BAKERSFIELD CITY SCHOOL DISTRICT
FRANKLIN ELEMENTARY SCHOOL MODERNIZATION
BAKERSFIELD, KERN COUNTY, CALIFORNIA

Job No. 1316
Appl. No. 15-6
File No. 03-122910

ADDENDUM NO. #05
NOTICE TO CONTRACTORS FIGURING THIS WORK

REF. DSA APPROVED DRAWING, SHEET A5.0

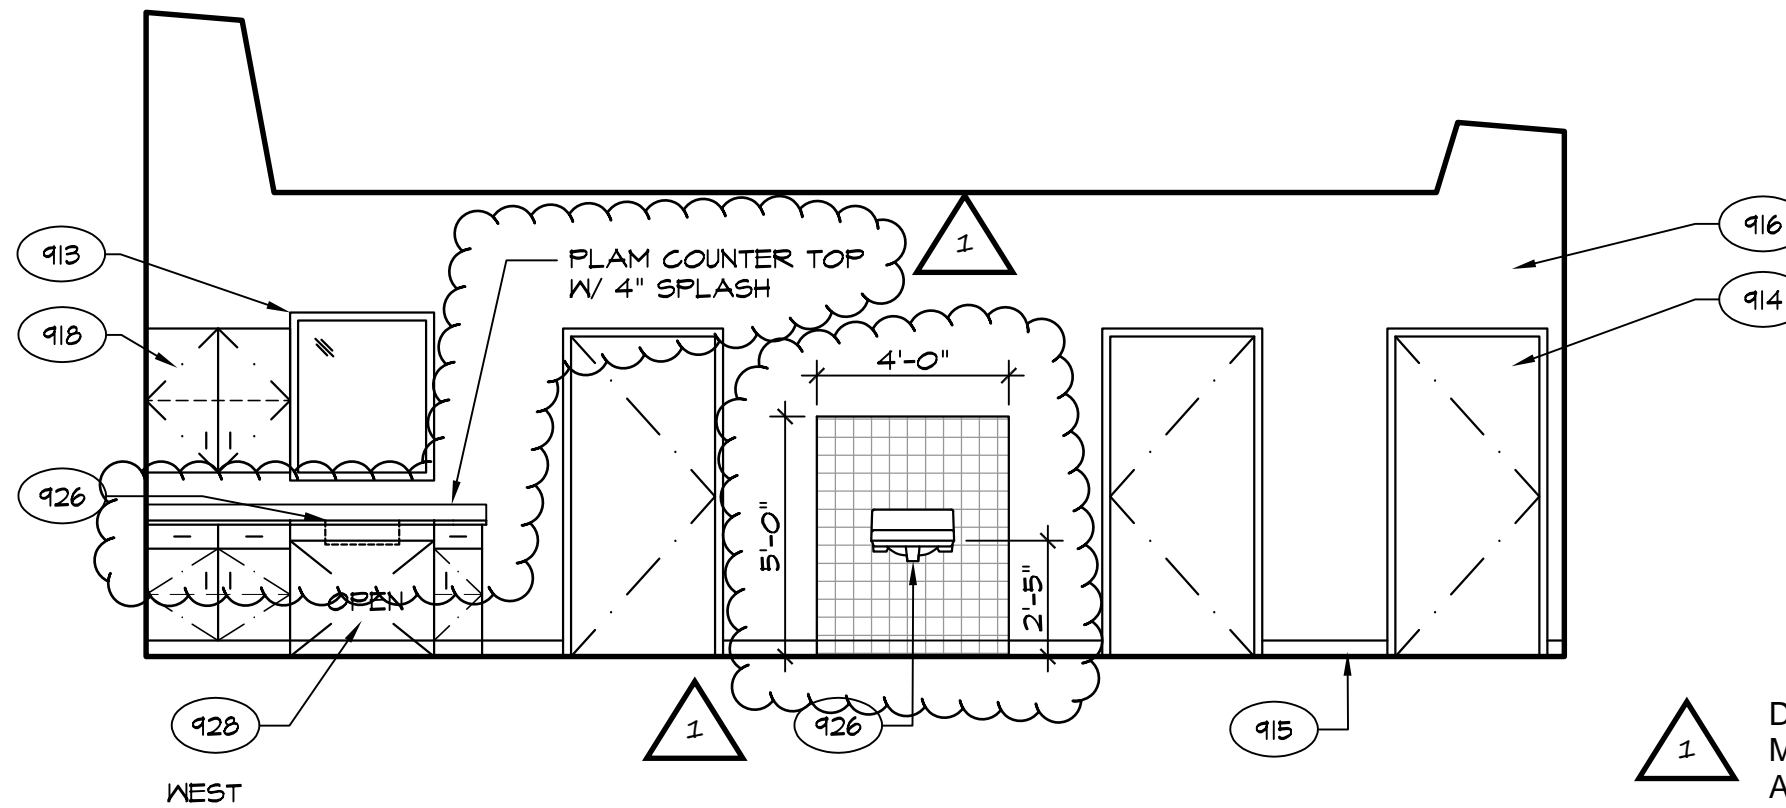
- a. REVISE: Wall finish to be 1C in lieu of 1A as indicated per attached Drawing No. 01.
 - b. REVISE: Ceiling finish to be 2C in lieu of 2A as indicated per attached Drawing No. 01.

- a. REVISE: Floor finish and base finish as indicated per attached Drawing No. 01.
- 5-8) Refer to Addendum No. 01, Item 1-1)b. Division 00 PROCUREMENT AND CONTRACTING REQUIREMENTS, Section 00 21 13.1 BIDDER INFORMATION AND FORMS, BP-02 GENERAL TRADE;

ITEM • 5-12)a
REF. DSA APPROVED
DRAWING, SHEET A9.1

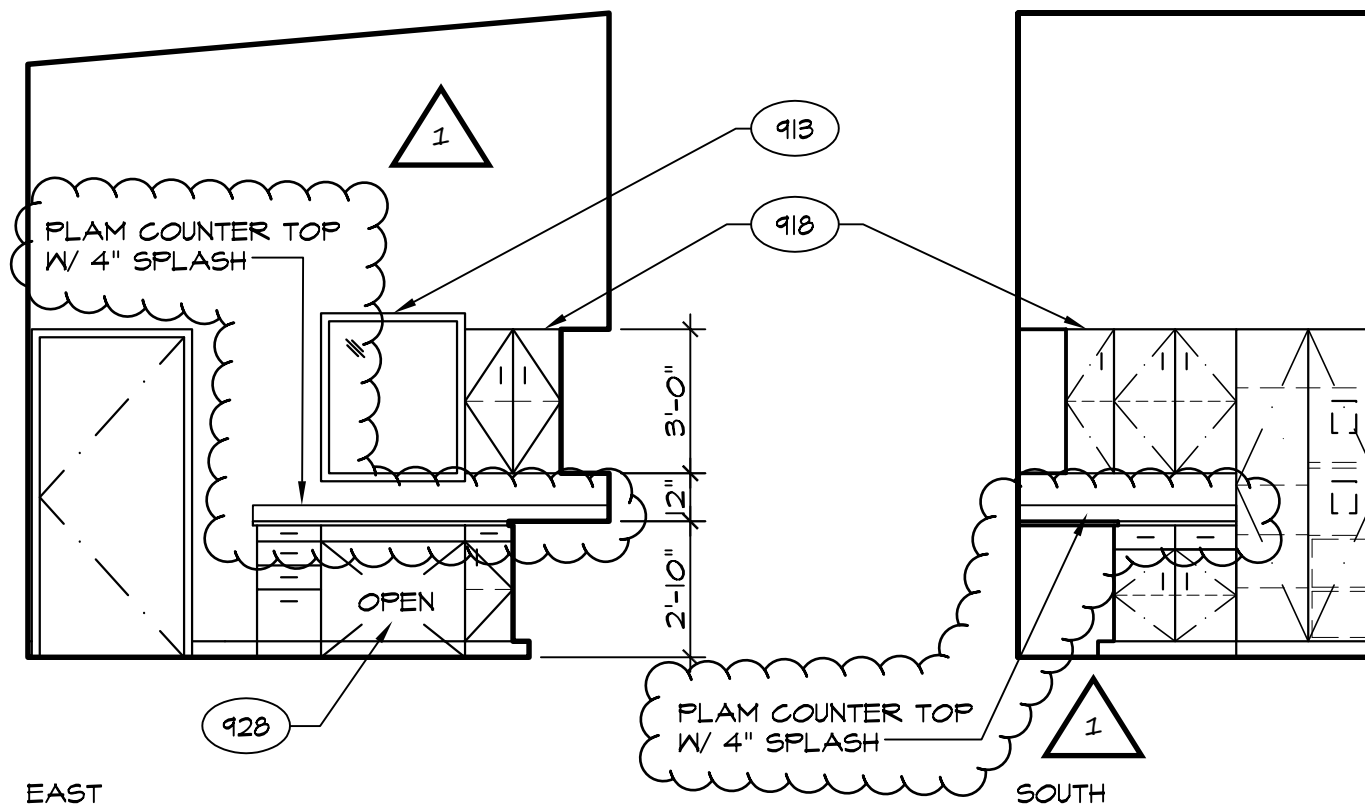
- a. ADD: At 401 West and 402 East & West, 4" backsplash as indicated per attached Drawing No. 02.
- b. CLARIFY: At 401 West and 402 East & West, countertop is to be plastic laminate as indicated per attached Drawing No. 02.
- c. ADD: At 401 West, ceramic tile at lavatory as indicated per attached Drawing No. 02.

DEFINE COUNTER TOP
MATERIAL, ADD SPLASH,
ADD CERAMIC TILE AT LAV

ITEM # 5-14
REF. DSA APPROVED DRAWINGS, SHEET A6.0

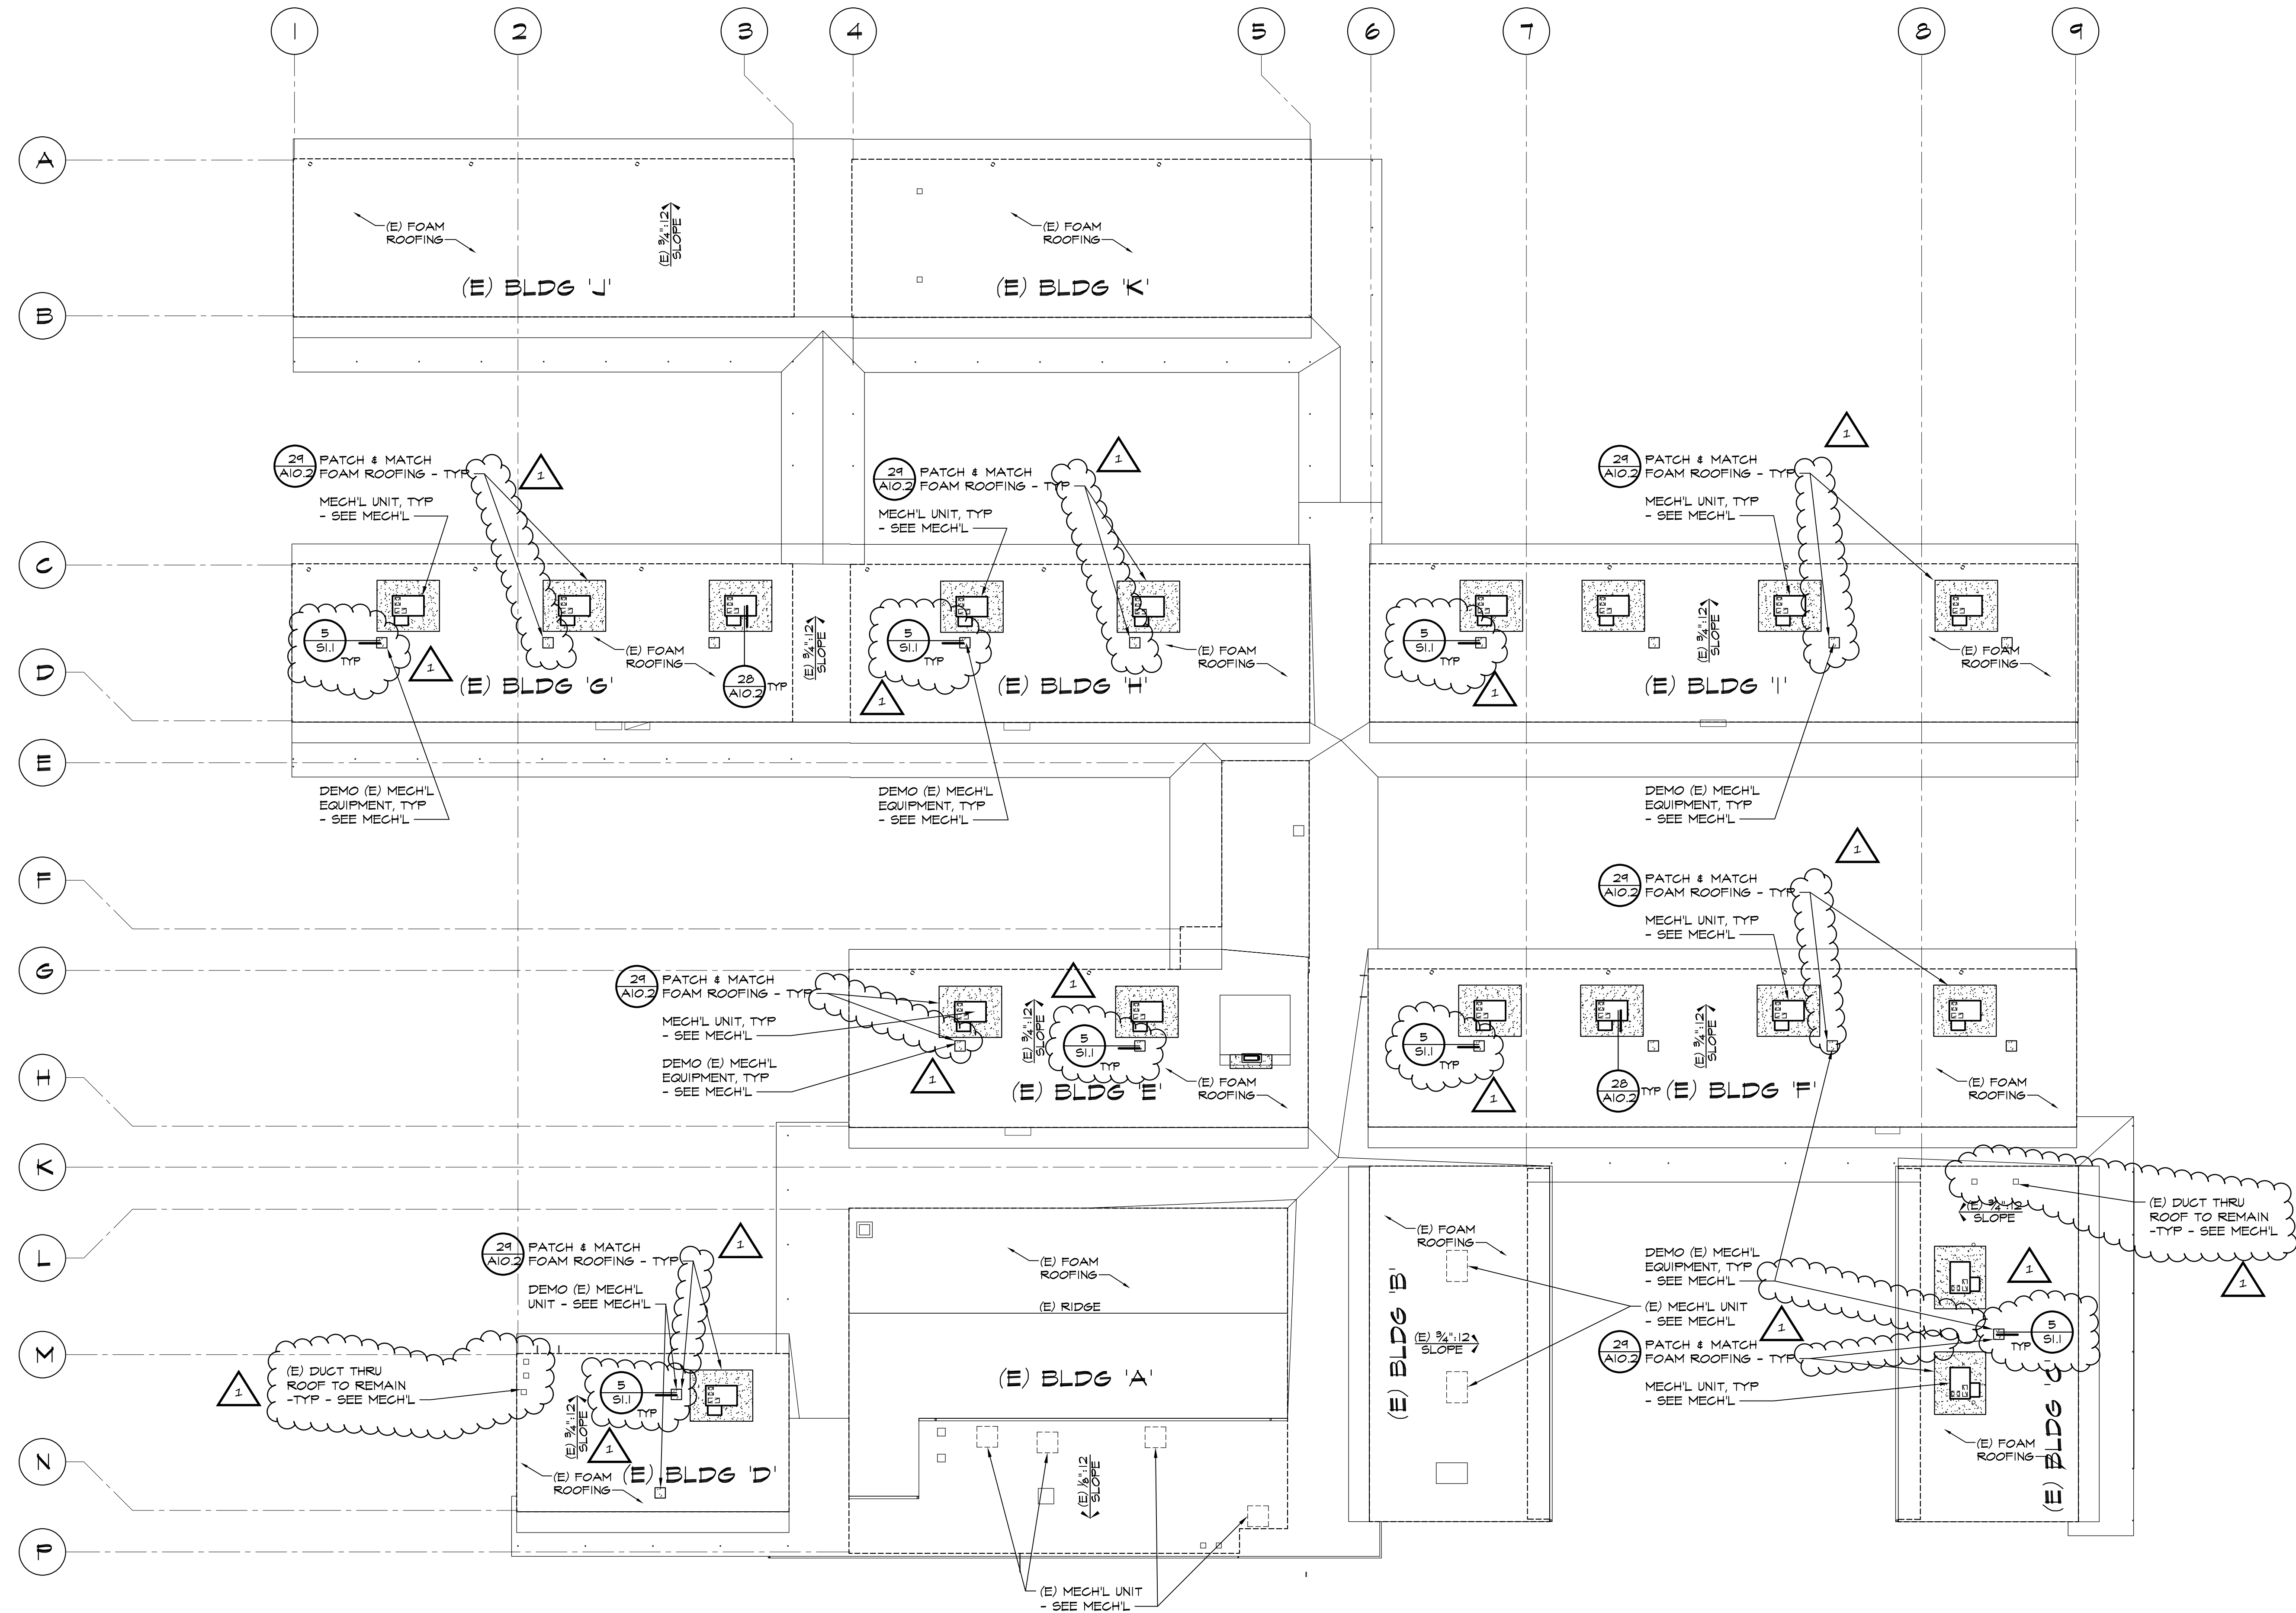
- a. ADD: Detail Key 5/S1.1 for existing vent opening infill as indicated per attached Drawing No. 03.
- b. ADD: (E) duct through roof to remain as indicated per attached Drawing No. 03.
- c. ADD: Patch (E) foam roof where mechanical equipment is demolished as indicated per attached Drawing No. 03.

▲ ADD ROOF DECK AND FOAM ROOF PATCHING

ITEM • 5-16)b
REF. DSA APPROVED
DRAWING, SHEET M1.0

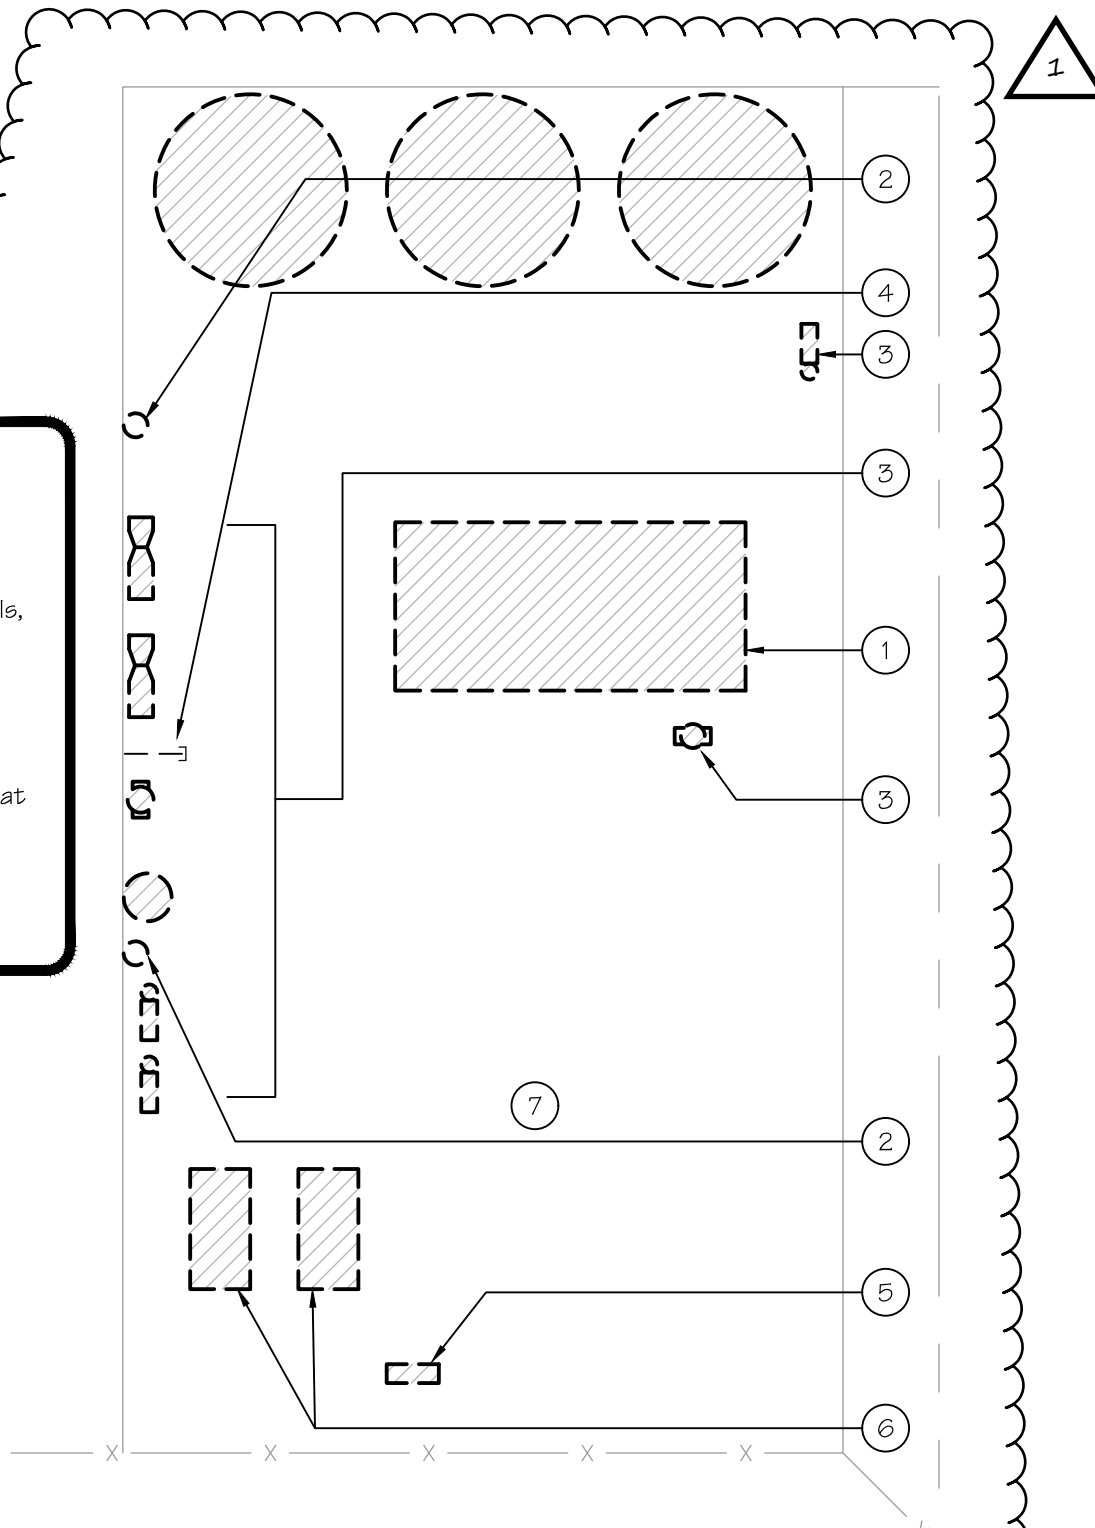
- b. ADD: Demolition of mechanical chiller and boiler yard equipment as indicated per attached Drawing No. 04.
- 5-17) Refer to Addendum No. 02, Item 2-13)a. Construction Schedule;

1 ADD DEMOLITION OF (E) CHILLER/BOILER
